CMD 22-H7.74A

Presentation from the Concerned Citizens of Renfrew County and Area

Application from the CNL to amend its Chalk River Laboratories site licence to authorize the construction of a near surface disposal facility Laboratoires Nucléaires Canadiens (LNC)

Commission Public Hearing Part 2 Audience publique de la Commission Partie 2

This figure from the 2014 *Comprehensive Preliminary Decommissioning Plan* shows contaminant plumes from Waste Management Area A and the Liquid Dispersal Area. The proposed location of the NSDF would be under the legend box for the figure.

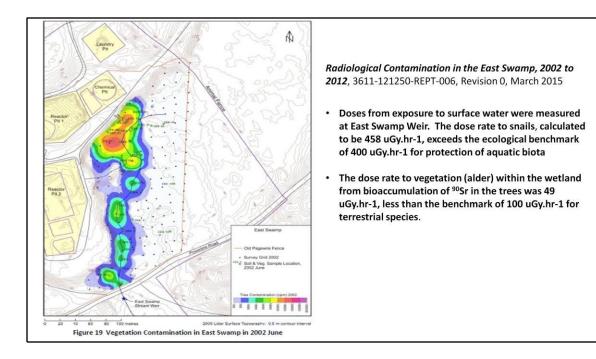
The yellow plume contains tritium, the radioactive form of hydrogen. This tritium plume discharges directly into Perch Lake. The purple plumes contain strontium-90, one of the major products generated by fission of the uranium-235 isotope in a nuclear reactor. These strontium-90 plumes discharge into streams that flow into Perch Lake.

In Waste Management Area A, radioactive wastes were dumped into unlined sand trenches. The serious accident that occurred in the NRX reactor in 1952 generated large quantities of both liquid and solid radioactive waste. Contaminated water was pumped uphill through a hastily constructed pipeline and discharged in the Liquid Dispersal Area. The highly contaminated original NRX reactor core is buried in the sand at Waste Management Area A. The pipeline continued in use until around 2000. After this practice was stopped, the pit was filled with radioactively contaminated equipment and vehicles.

This figure shows radiation levels in vegetation – mostly alders – downslope from the Liquid Dispersal Area in the East Swamp wetland, where a so-called "exfiltration gallery" would discharge partially treated leachate from the NSDF mound.

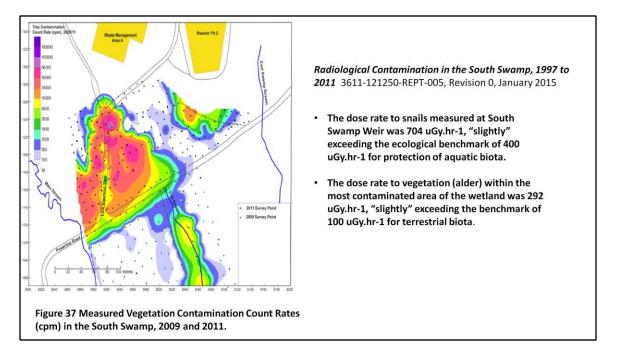
When measurements were made in 2002, radiation counts in alders growing in the orange and red zones exceeded ten thousand per minute. Radioactivity in the alders largely represents strontium-90 disintegrations.

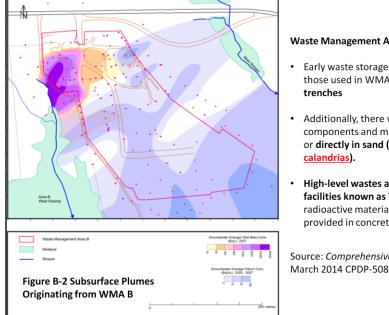
Radiation doses to snails, measured in the green zone where the East Swamp Stream crosses the Powerline Road at the East Swamp Weir, exceeded the benchmark for protection of aquatic life.

The South Swamp wetland receives discharges from Waste Management Area A, just to the west of the Liquid Dispersal Area. Here, the orange and red zones (with radiation counts in alders exceeding ten thousand per minute) are much larger. Both alders and snails in the South Swamp receive radiation doses that exceed benchmarks for protection of living organisms.

A groundwater treatment system was installed in 2013 to remove strontium-90 from the plume originating from Waste Management Area A. However, until action is taken to address the "source terms" in Waste Management Area A – the wastes themselves – radioactivity will continue to leak into the South Swamp.

Waste Management Area B

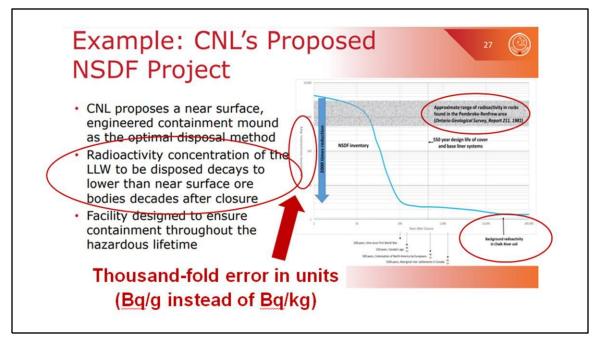
In Waste Management Area B, like Waste Management Area A, radioactive wastes were dumped directly into unlined trenches in the sand. This figure shows tritium plumes in blue, and strontium-90 plumes in purple, from Waste Management Area B. As with the plumes from Waste Management Area A, these plumes discharge into streams that flow into Perch Lake.

So-called "special burials" in this area included the second NRX reactor core and the first NRU reactor core. There are many concrete tile holes at Waste Management Area B, some containing high-level spent fuel wastes. Water has gotten into some of the tile holes. A fuel repackaging project has retrieved some of the affected highlevel wastes, dried them, and put them in more secure above-ground storage.

A Geologic Waste Management Facility:

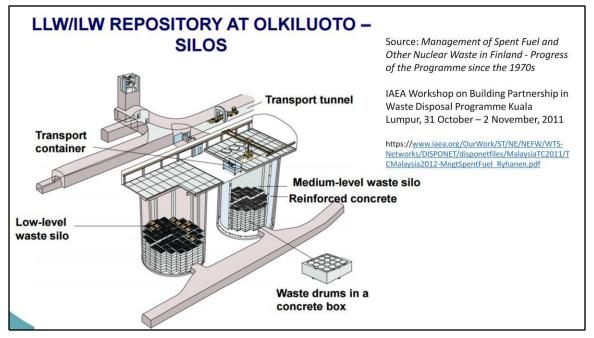
CNL's 2017 draft *Environmental Impact Statement* (EIS) for the mound describes a number of advantages of a geological facility for managing radioactive waste. These include increased barriers against releases to the environment, increased barriers against groundwater contamination, and lack of infiltration of precipitation into the waste during emplacement.

Perhaps the most important advantage of a geological facility is the greatly decreased likelihood of future human intrusion into the wastes. The IAEA recommends that long-lived radionuclides be put in a geological facility, because risks of human intrusion remain for many thousands of years, long after information about the wastes and the facility itself will have been lost.

Nonetheless, the geological facility alternative was rejected, largely because it would take longer to build and cost more – while noting that the cost estimates are very poorly documented by CNL and completely ignored in CNSC's EA report.

Other countries with similar geology to Canada have moved ahead with geological facilities for their low-and intermediate-level radioactive wastes. This figure shows a facility in Finland that conforms to IAEA safety requirements.
